MEMORANDUM

Subj: Staff Review Comments – S. Darrow Road Townhomes Case 21-1248

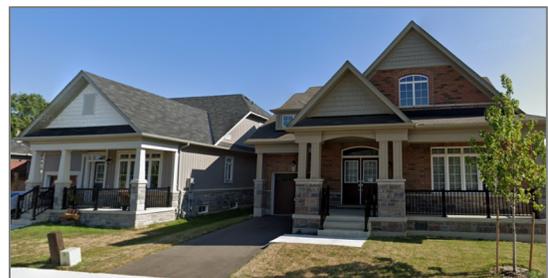
Staff notes the project was presented to the AHBR for informal review at the 1.12.22 AHBR meeting. During the meeting, significant discussion occurred on the placement of the garage doors relative to the front entryway. The Board concluded that aligning the front entryway and garage doors on the same elevation could be considered due to the location of the development and the significant setback from Darrow Road; however, making a recommendation is challenging without seeing a proposed elevation. Other discussion items included:

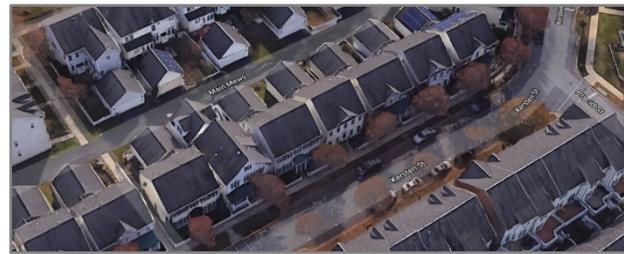
Staff Comment: Staff notes the intent of the regulation to minimize view of garages should be met by designing a more prominent/wider entryway and setting back garage doors/garage masses from the front face of the building.
